ARKANSAS
Department of Environmental Quality

RE: Compliance Inspection
AFIN: 63-00065; NPDES Permit No.: AR0034002; No Exposure Certification ARR00C408

NPDES Compliance Inspection Report

Re: Plan to Decommission Sludge Storage Lagoon Outfall Structure
NPDES Permit No.: AR0034002
Bryant, Arkansas

**FIGURE 1
DECOMMISSIONING OF SLUDGE
LAGOON OUTLET STRUCTURE**

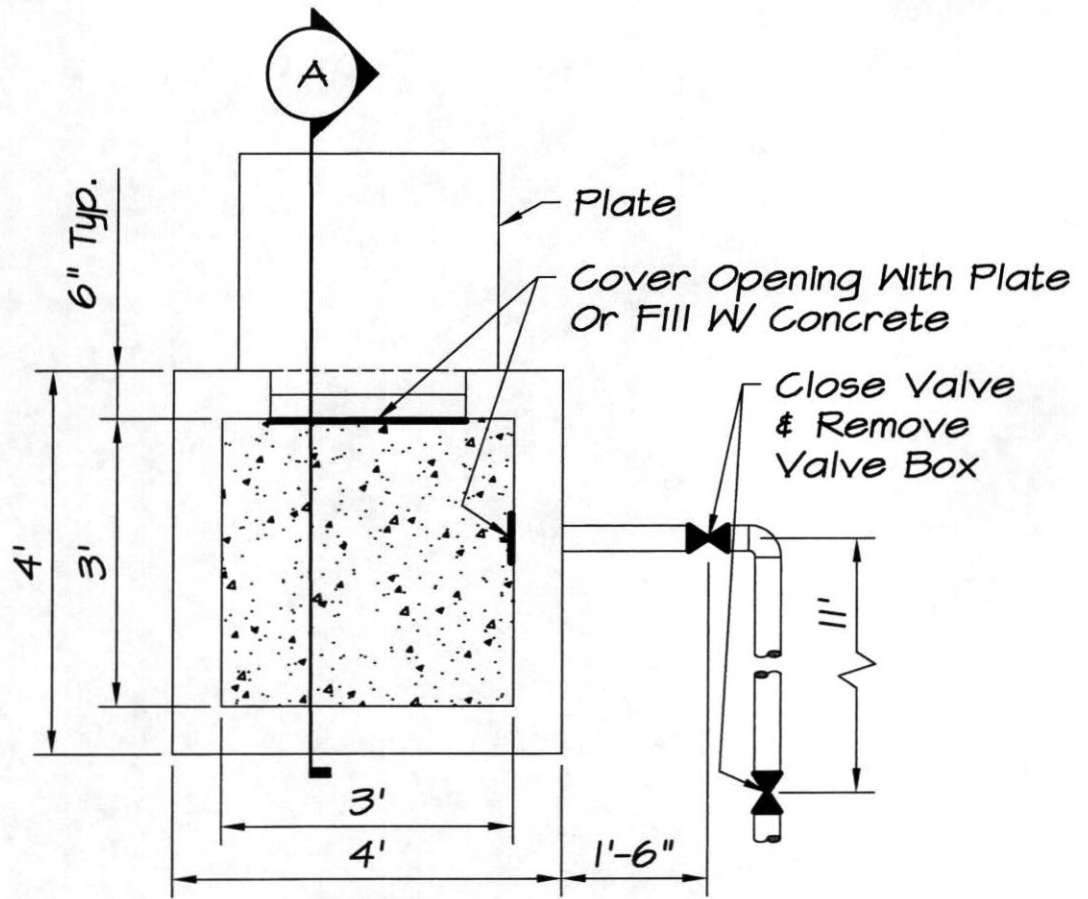
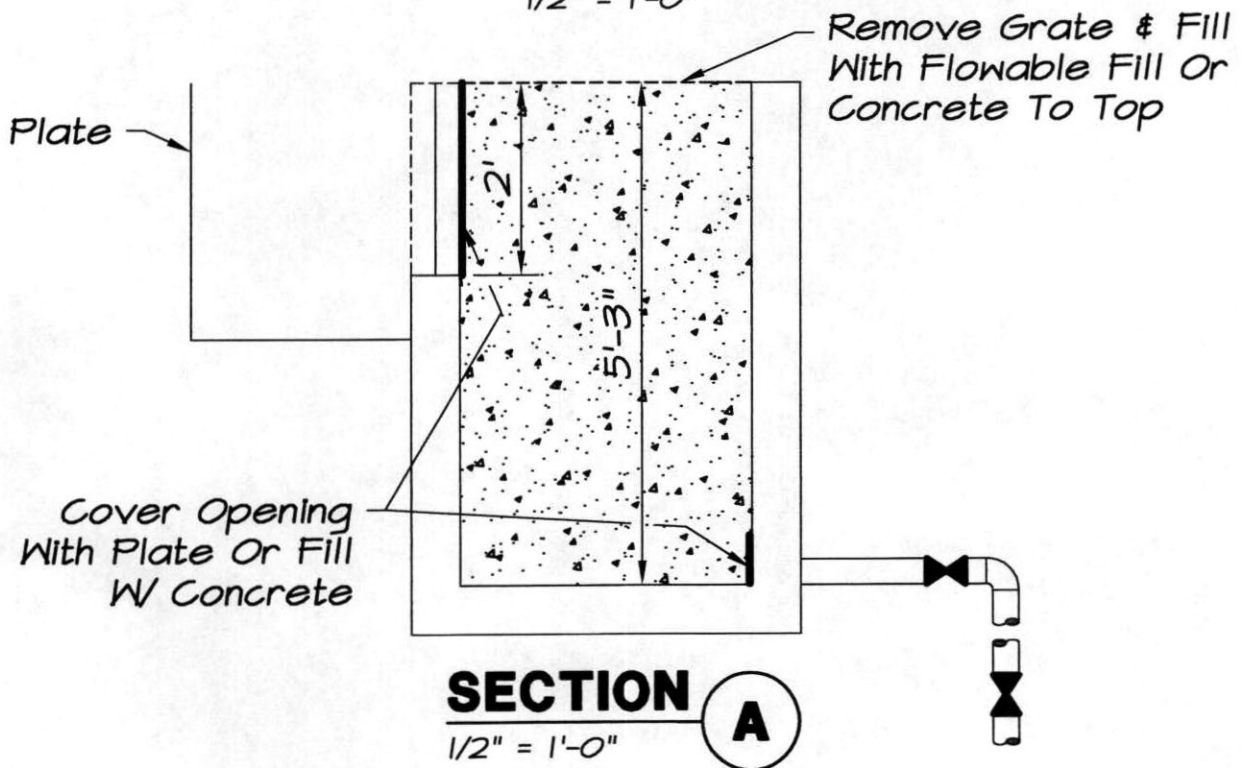
- 1) The letter dated June 28, 2013 was not signed by the Responsible Official on record for NPDES Permit No: AR0034002.
- 2) Regarding the request to decommission the sludge lagoon outfall structure, it is necessary to submit a formal plan to the ADEQ Water Division Permits Branch complete with drawings to illustrate exactly how the City proposes to close the outfall. This plan is required to include a specific date by which the outfall structure will be decommissioned. Kimberly A. Fuller, P.E. NPDES Engineer Supervisor, ADEQ Water Division, can be contacted at (501) 682-0643 for additional information.
- 3) A date by which the vegetation will be removed from within the sludge lagoon and around the embankments is required to be submitted in response to this inspection report.

Upon request by Risa Parker (District 9 Field Inspector), the following plan to decommission the outfall from the sludge storage lagoon is hereby presented for review and approval.

Currently there is a concrete outlet structure with drain piping and a valve that is connected to the 24-inch outfall from the wastewater plant. The City of Bryant has previously submitted a plan to ADEQ to decommission the structure and drain pipe; however, due to the location and depth of the pipe, the City has not been able to safely excavate the drain piping in order to remove the valve and a section of pipe. The City is requesting approval to modify the plan as follows:

1. Remove the grate at the top of the structure.
2. Block off the outlet piping inside the concrete outlet structure or fill it with concrete.
3. Fill the structure with flowable fill or concrete to the top of the structure. This method would prevent excavation of the sludge lagoon levee and would be a much safer alternative.
4. Close the valve(s), remove the valve box(es) and fill the void(s) with dirt to prevent access to the valve.

The City of Bryant will decommission the structure within 60 days of receiving ADEQ approval of this formal plan.
